**CERTIFICATE OF APPROPRIATENESS**

**Property:** 417 West 12<sup>th</sup> Street, tract 19a, 20a, and 21a, block 183, Houston Heights Subdivision. The property includes a historic 1,007 square foot residence situated on a 4,100 square foot (41' x 100') interior lot.

**Proposal:** Alteration – Construct a two story 1,498 square foot addition on top of and to the rear of a one story 1,007 square foot Contributing residence.

**Recommendation:** Denial – Does not satisfy criteria 1, 4, 8, and 9.

**EAST SIDE ELEVATION**

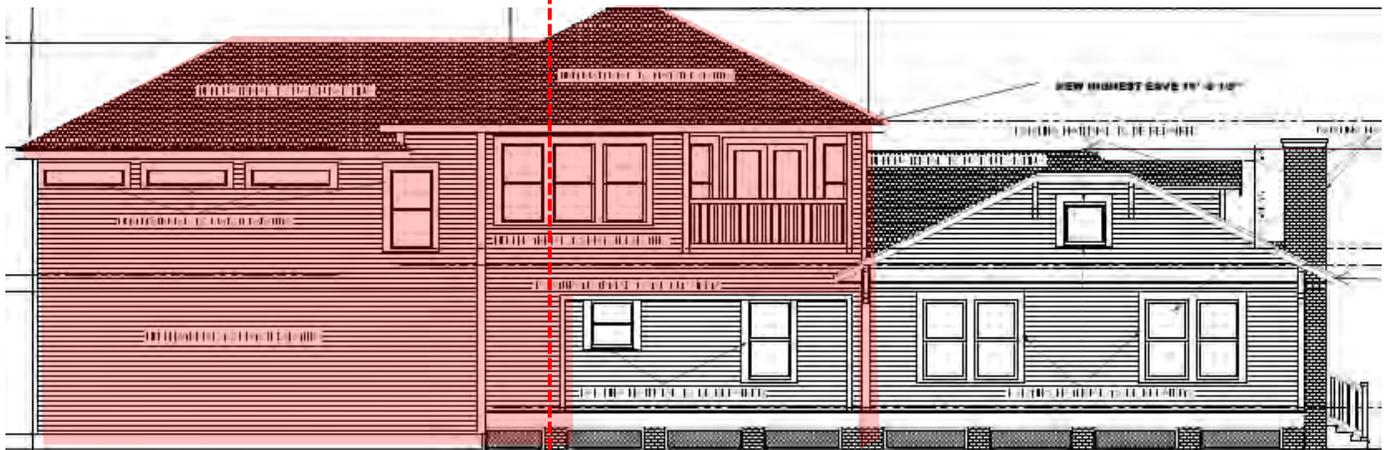
| (8) Proposed additions or alterations must be done in a manner that, if removed in the future, would leave unimpaired the essential form and integrity of the building, structure, object or site;<br><i>The proposed second floor addition will result in the loss of over half of the existing home's roof structure and a 10' deep rear addition. Furthermore, the placement of a second floor over the existing residence jeopardizes the essential form and integrity of the structure, as the exterior walls are often heavily altered or replaced in order to carry the added weight of the second floor.</i> |                                     |                          |                      |                             |                            |

**Side Elevation:** The addition will begin approximately 27' from the front wall, encroaching over the rear 19' of the original structure. A 10' deep non-original rear addition will also be removed in order to incorporate the new addition. The portion of the addition encroaching over the house will be clad in wood shingles and will feature three windows. The side facing attached two story garage will be inset 7' from the rest of the house. This portion of the addition will feature new wood 117 siding and two windows.  
**(East)**

**WEST SIDE ELEVATION**

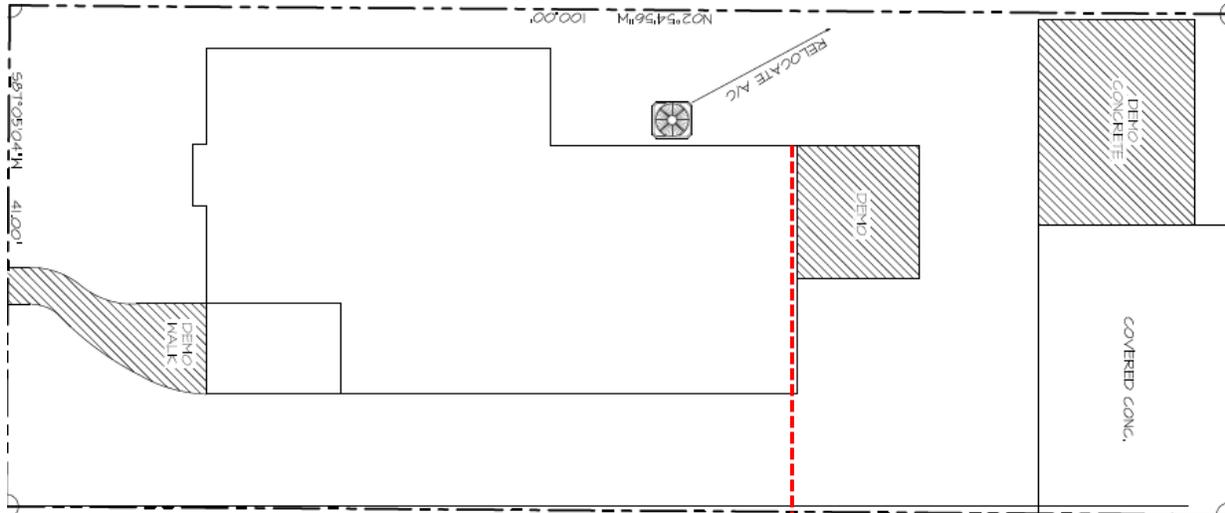
**Side Elevation:** The addition will begin approximately 27' from the front wall, encroaching over the rear 19' of the original structure. A 10' deep non-original rear addition will also be removed in order to incorporate the new addition. The portion of the existing home behind the side gable is inset 7' from the front portion of the house. The addition will preserve this condition on the first floor but will build second story living space above the inset area. The result will be a covered side porch facing the west side property line. The second story of the addition will feature a side facing upstairs balcony directly above the first floor porch.  
**(West)**
